MEMORANDUM TO: Tolbert Young, Section Chief, Region V

SUBJECT: TEAM INSPECTION - PALO VERDE UNIT 1

APPENDIX A

NOTICE OF VIOLATION

Pass 2 of 2
NCR PA-386

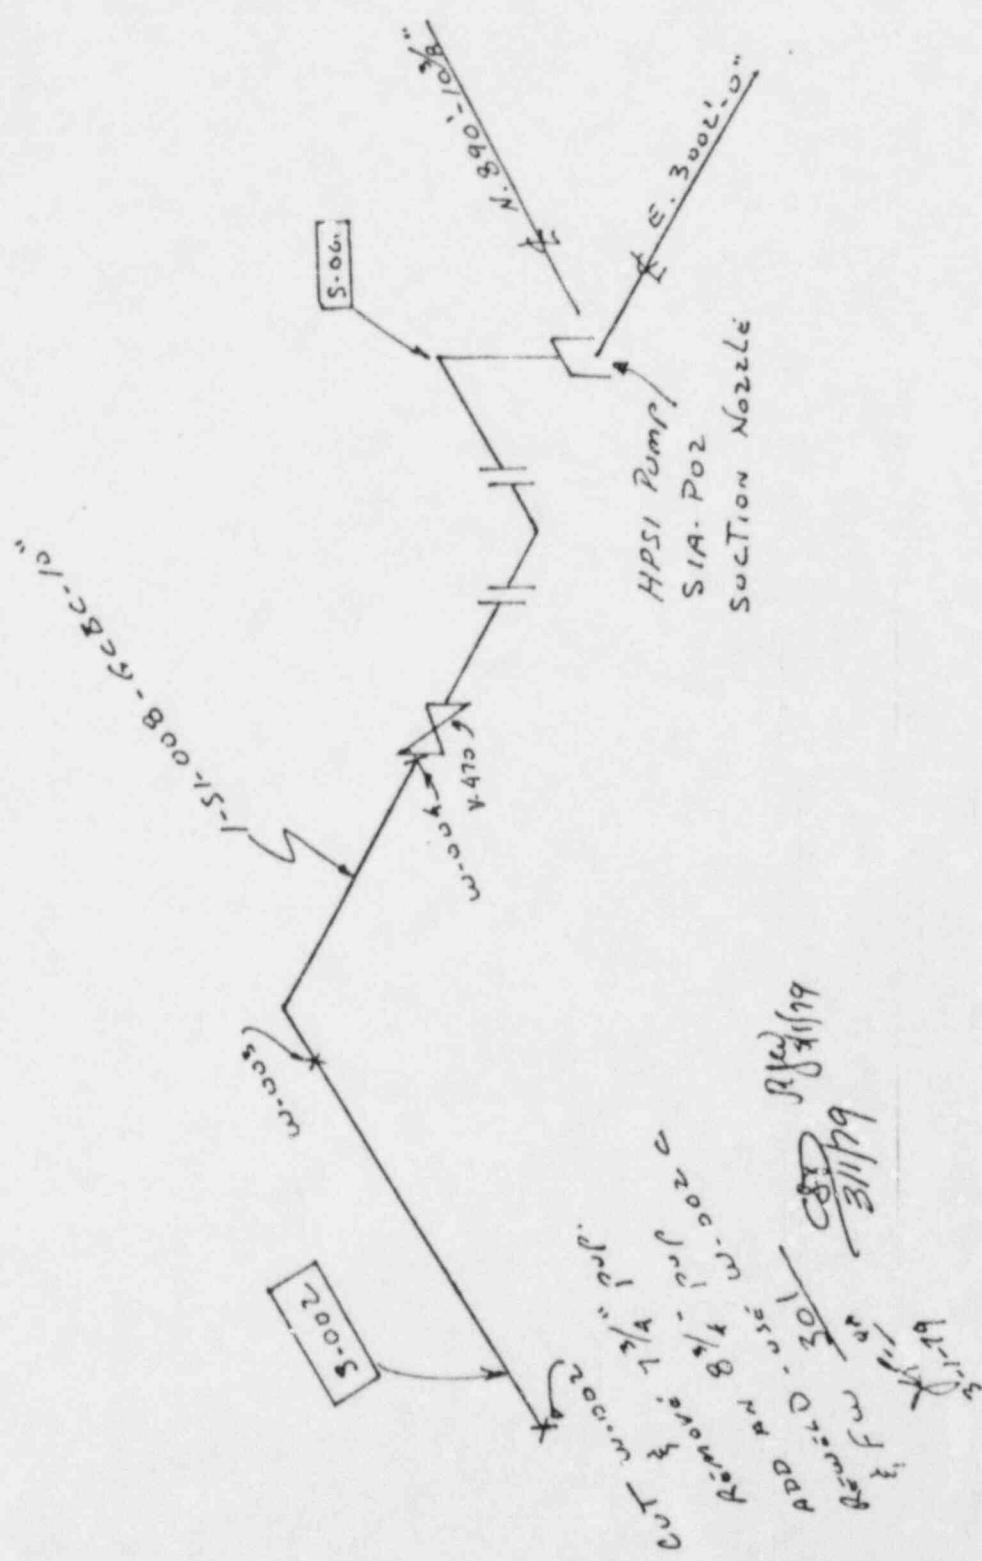
12. DESCRIPTION			12. FIELD ENGR. DECISION	13. FIELD RECOMMENDED DISPOSITION
1. Dwg. 13-P-S1/F-20/ Rework shows Centrifuge line of HPSI Pump SIA-B2 Suction nozzle located at E. 3002.0". The center line of spool 1-S1-008-5006 is at E. 3001.11". Scales have a 1" misalignment.			1. $\frac{1}{2}$ z.	CUT A $7\frac{3}{4}$ " SECTION FROM SPOOL 1-S1-008-5002 AT POINT INDICATED ON SKETCH & REPLACE WITH AN $8\frac{3}{4}$ " long, 10"Ø, S/20 S.S., SA-312, GR.TP. 304. PUP. REWELD USE W-002 C.

YOKE & OPERATOR OF
1.PS1B V-102 ("E" 4PSI Pump
Suction Line)

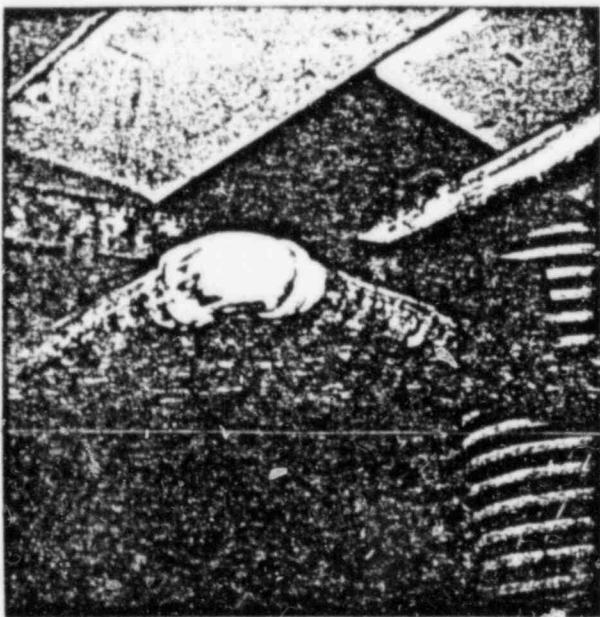
- 1.5 Failure of this operator and the observed condition of the "B" HPSI Pump suction isolation valve as not fully open despite inability to obtain further valve stem travel indicates that verification of full stem travel capability on all rising stem manual valves should be performed. Startup should add this verification as a generic test for all safety related manually operated rising stem valves.

SPRINKLER PIPE WHICH HAD
BEEN IN CONTACT WITH
IRSIAV47D OPERATOR

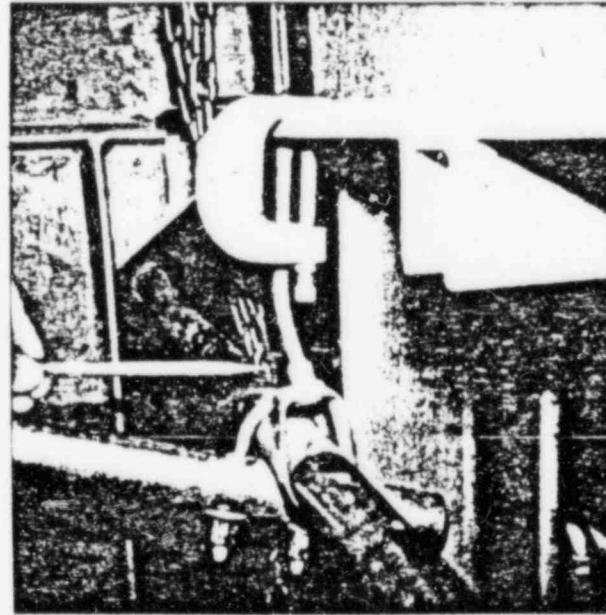
"Stackup" and location measurements of the Fire Protection System piping and 1PSIAV470 verify that interference between the valve operator and the piping elbow existed. This conclusion is further supported by a wear line on the elbow approximately 1/2" from the bottom of the elbow and by paint removal on the sides and edges of the hammer section of the valve operator.
